Re: Turkey Point Units 3 and 4
Docket Nos. 50-250 and 50-251
Response to NRC Reactor Systems Branch Request for Additional Information
Regarding Extended Power Uprate License Amendment Request No. 205
and Nuclear Fuel Design

RESPONSE TO NRC NUCLEAR PERFORMANACE AND CODE REVIEW BRANCH
REQUEST FOR ADDITIONAL INFORMATION REGARDING
EXTENDED POWER UPRATE LICENSE AMENDMENT REQUEST NO. 205
AND NUCLEAR FUEL DESIGN

Updated Seismic/LOCA Analysis Information Following the NRC Audit, January 19, 2012

Figure 3 – Turkey Point 3

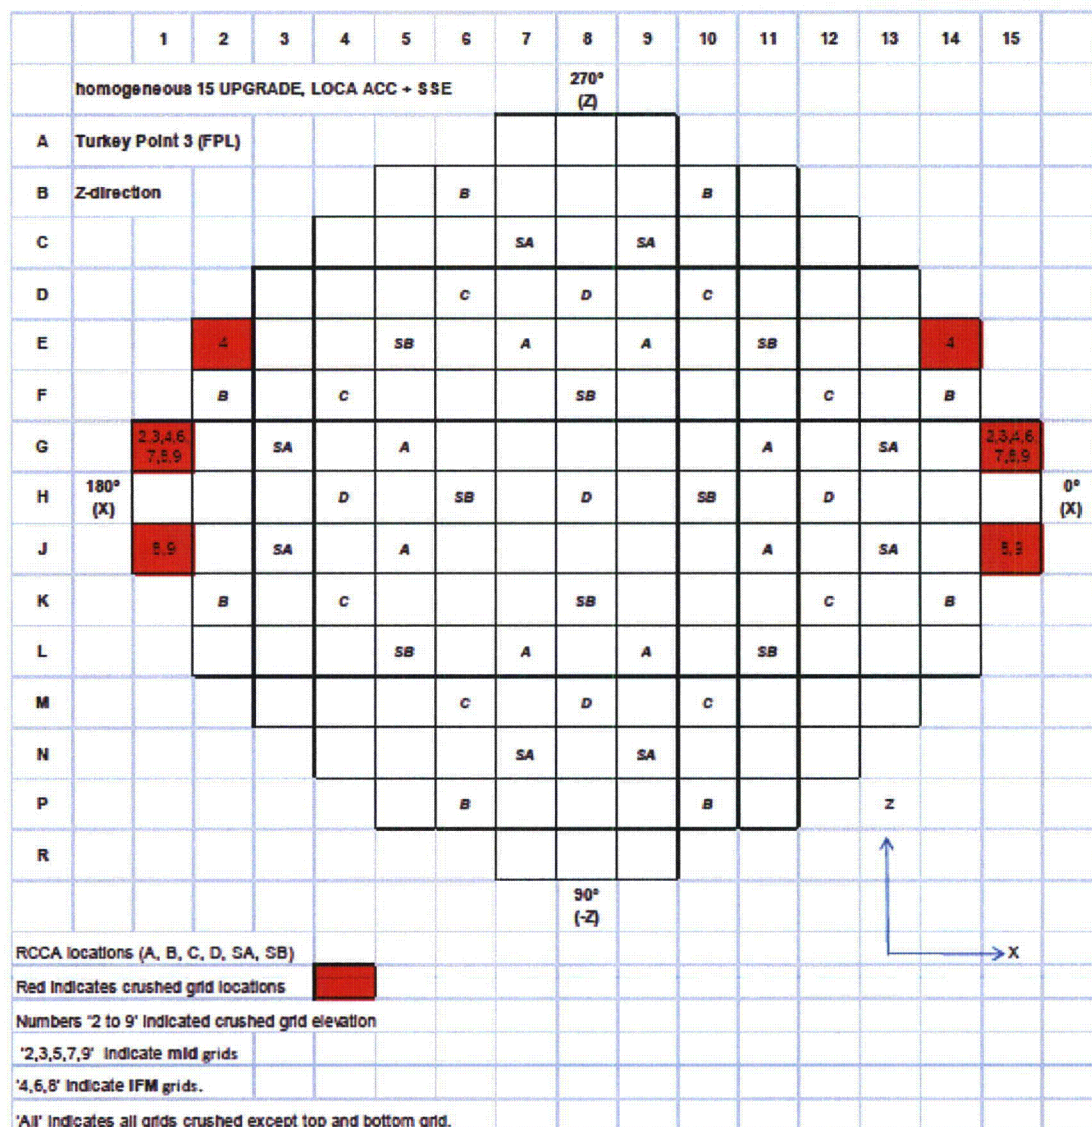
Figures 3 and 4 show a core map for Units 3 and 4, respectively, indicating the fuel assembly locations for which the analysis results show grid deformation for the homogenous 15x15 Upgrade fuel assembly core. In this case, the results found that the impact force on the fuel assemblies in all RCCA core locations were below the allowable grid crush limit.

Figure 5

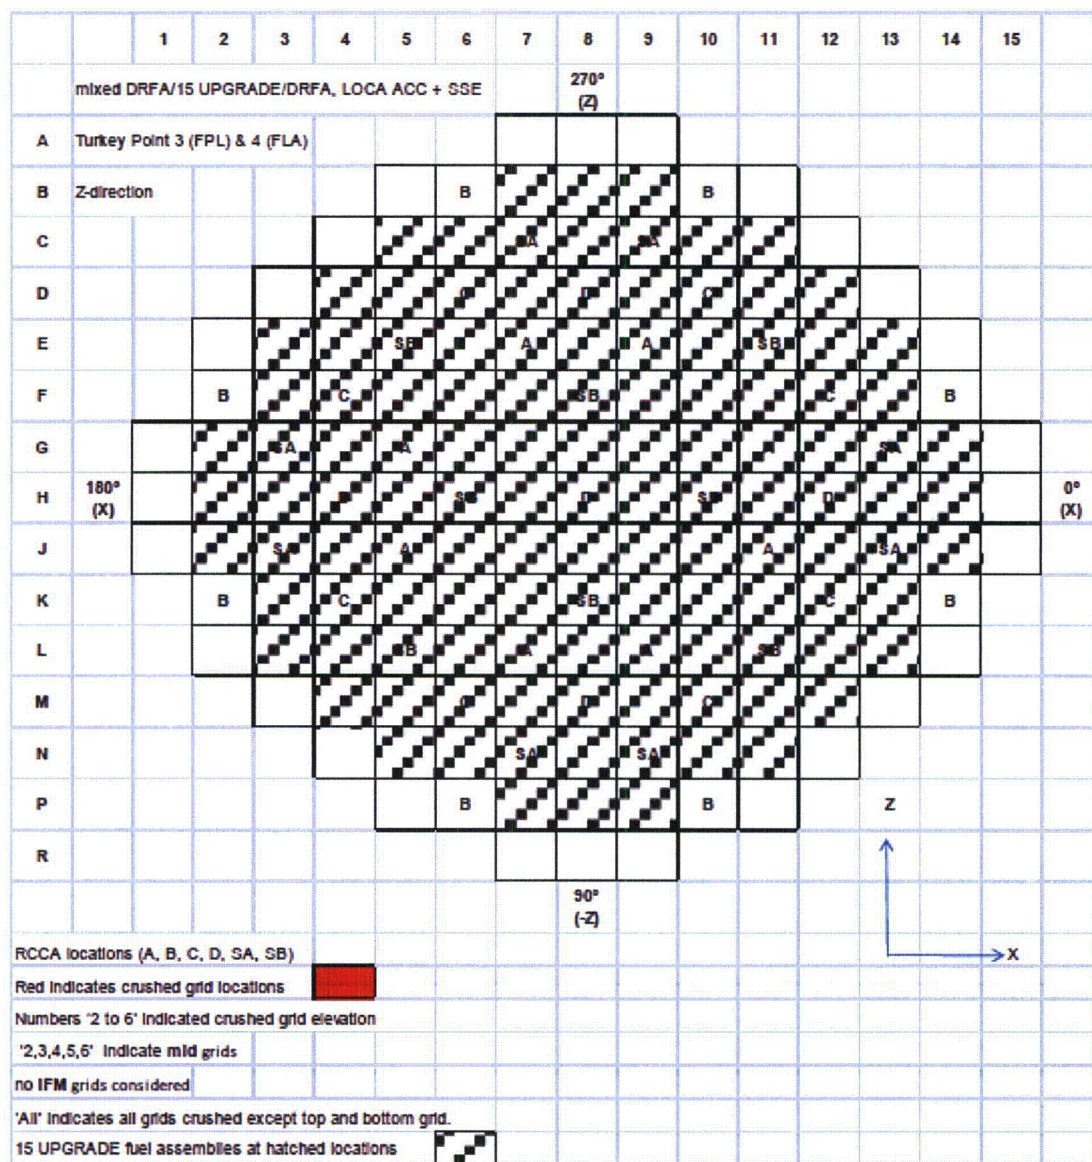
Figure 5 shows a core map for a transition mixed core with DRFA fuel assemblies in all core periphery locations. The results of the analysis for this case found that the impact force on all fuel assemblies were below the allowable grid crush limit.

Figure 6

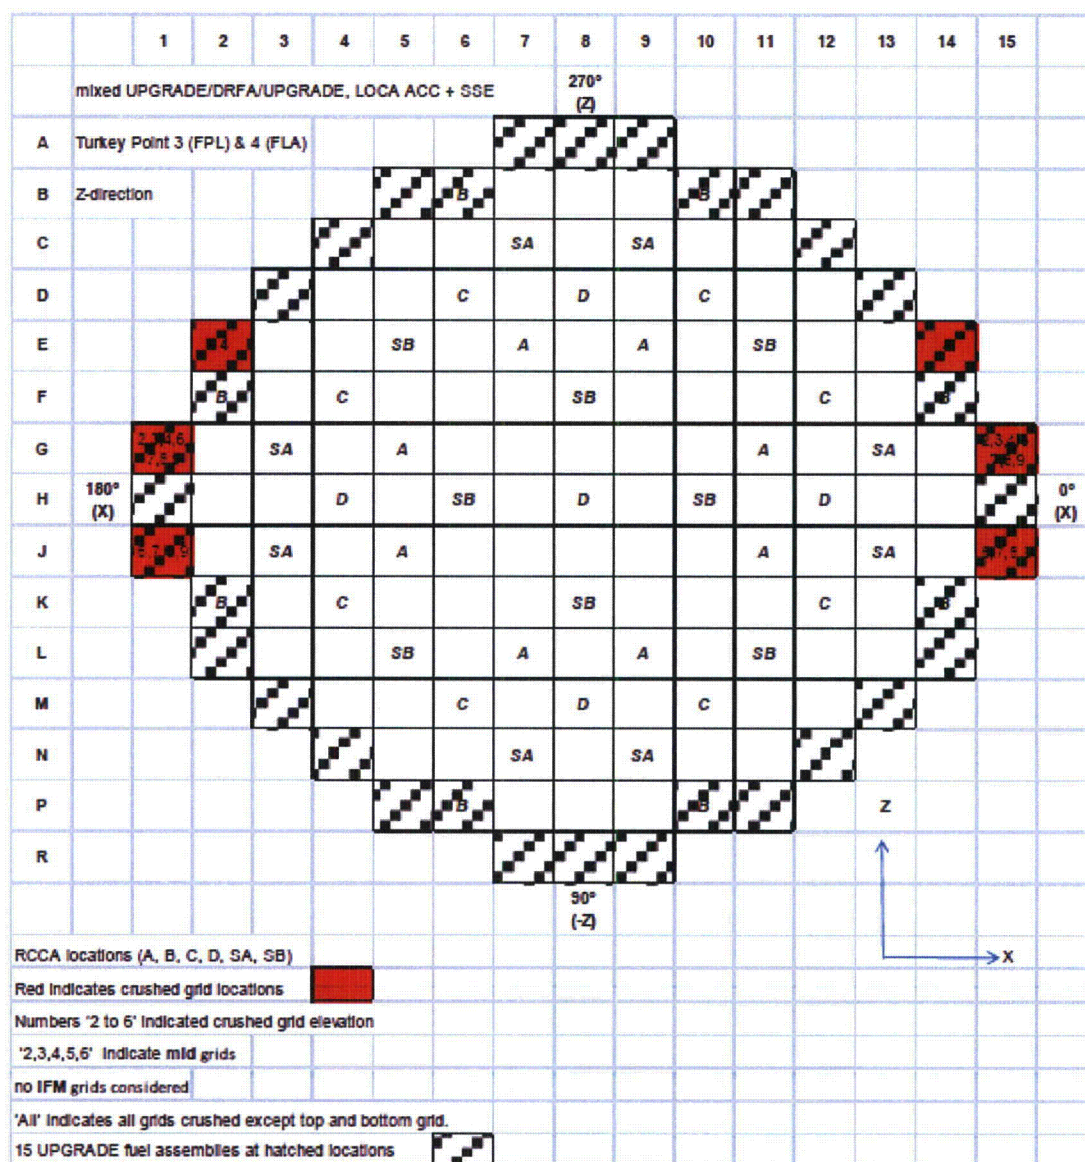
Figure 6 shows a core map indicating the fuel assembly locations for which the analysis results show grid deformations for a transition mixed core with 15x15 Upgrade fuel assemblies in all core periphery locations. In this case, the results found that the impact force on the fuel assemblies in all RCCA core locations were below the allowable grid crush limit.

Figure 7

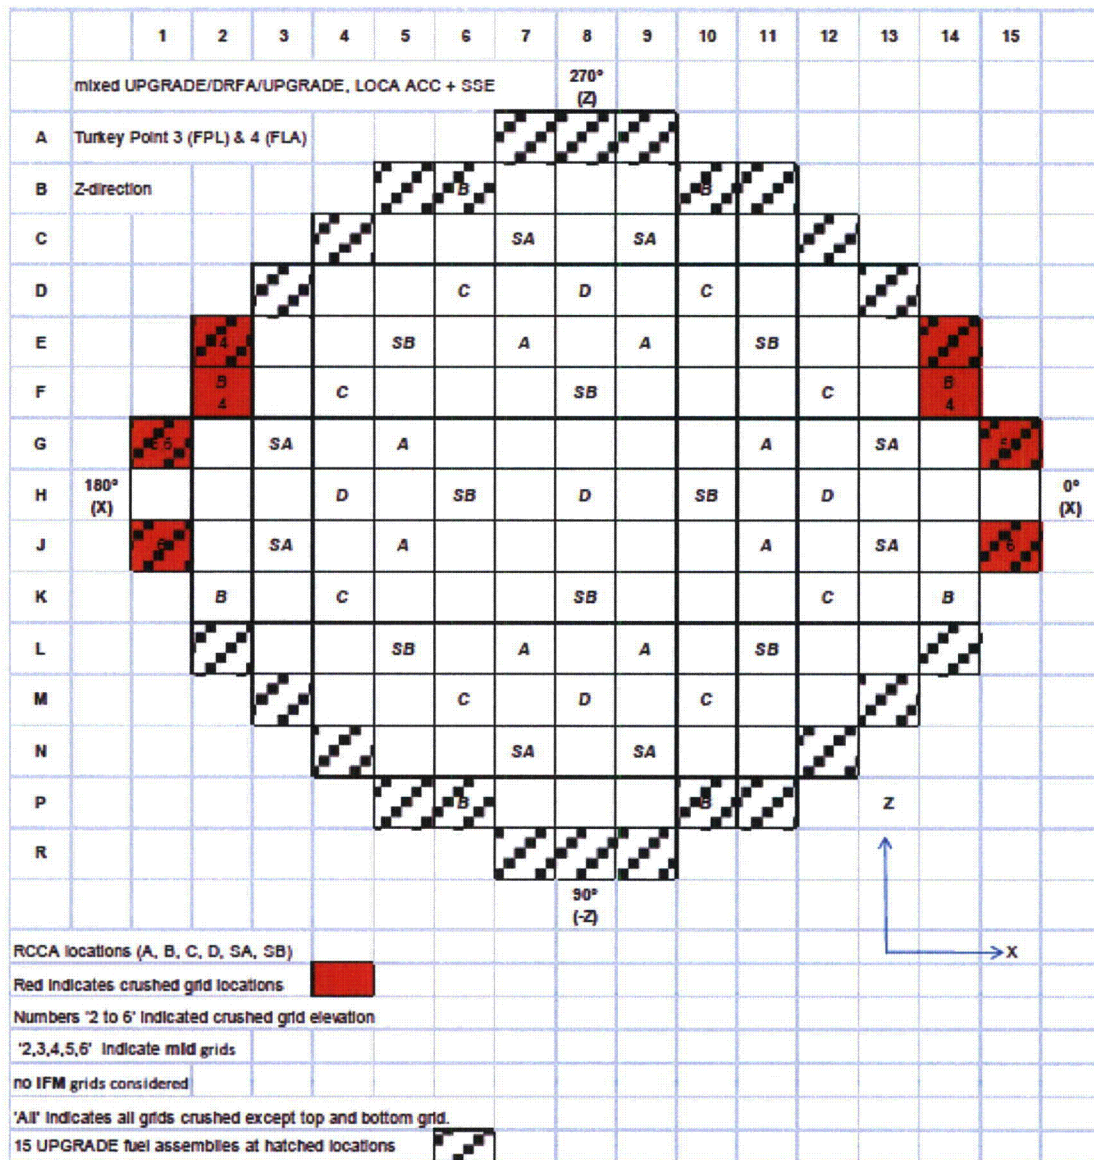
Figure 7 shows a core map indicating the fuel assembly locations for which the analysis results show grid deformation for a transition mixed core with 15x15 Upgrade fuel assemblies in all core periphery locations except core locations F-2, F-14, H-1, H-15, K-2, and K-14 which have DRFA fuel assemblies. In this case, the results show grid deformation in the fuel assemblies in RCCA core locations F-2 and F-14.

Figure 8

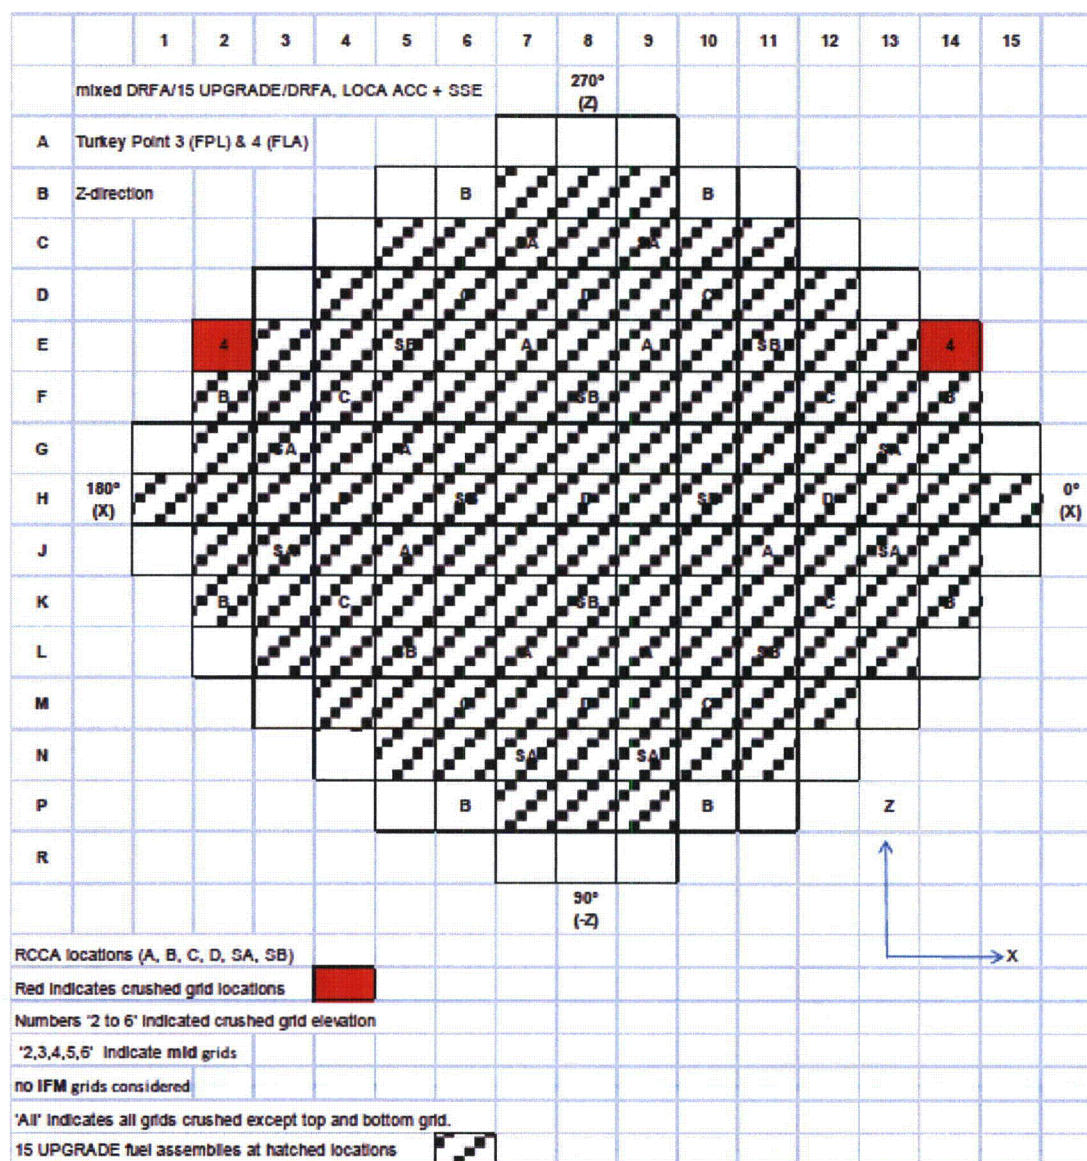
Figure 8 shows a core map indicating the fuel assembly locations for which the analysis results show grid deformation for a transition mixed core with 15x15 DRFA fuel assemblies in all core periphery locations except core locations F-2, F-14, H-1, H-15, K-2, and K-14 which have Upgrade fuel assemblies. In this case, the results found that the impact force on the fuel assemblies in RCCA core locations F-2 and F-14 were below the allowable grid crush limit.

An unlikely loading pattern condition was analyzed where the Upgrade fuel assemblies are placed in core locations E-2 and E-14 and DRFA fuel assemblies are placed in RCCA core locations F-2 and F-14. This was the only condition when grid crush was predicted to occur in fuel assemblies under an RCCA. To ensure grid crush in RCCA locations does not occur, an RSAC limitation is being maintained to assure that for 15x15 DRFA & Upgrade fuel assembly transition mixed cores, only DRFA fuel is loaded in core locations E-2 and E-14 when DRFA fuel is loaded in RCCA core locations F-2 and F-14.
